Addendum No. 1

RE: Contract # C204728

Robeson County (I-5987B)

I-95 FROM SOUTH OF NC-20 TO SOUTH OF PROPOSED I-295.

STATE	CITY PROJECT REFERENCE NO.	SHEET NO.	TOTAL SHEETS
N.C.	I-5987B	Sign-29	16
STATE PROJ.NO.	F.A.PROJ.NO.	DESCRIPTION

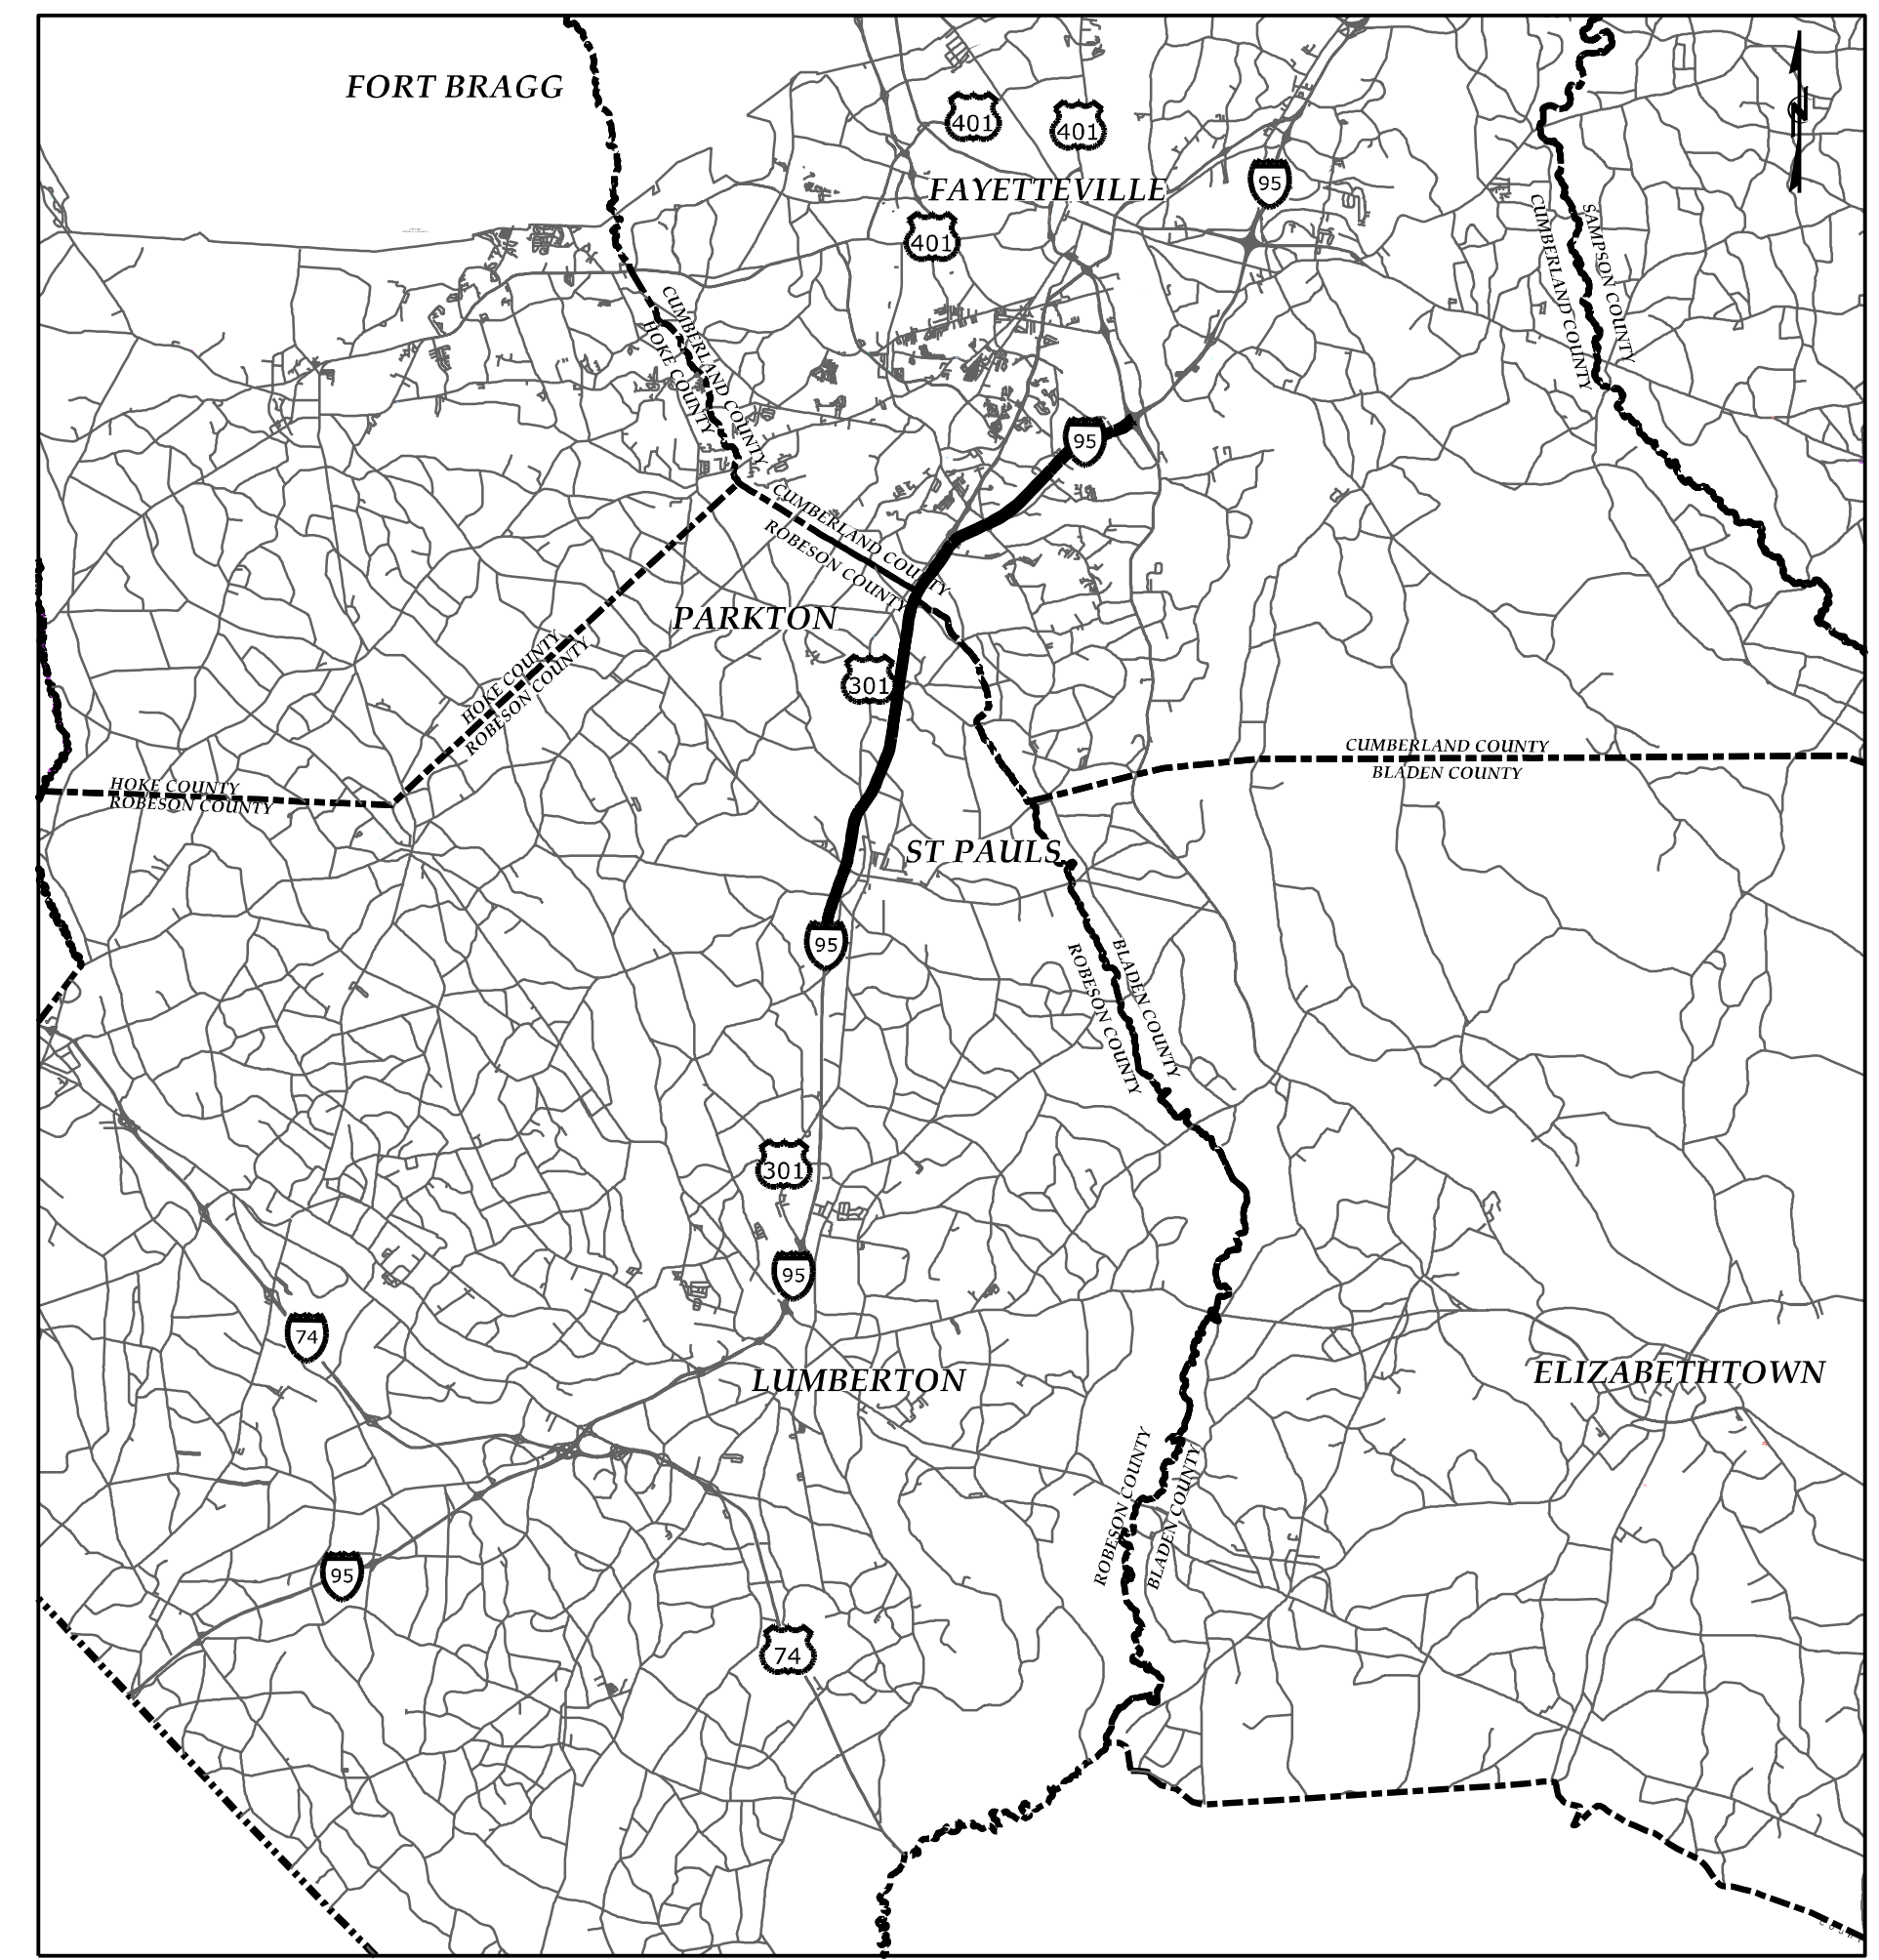
Sheet No.	Revision
SIGN-29 thru SIGN-44 (New)	Added Trailblazer Signs.
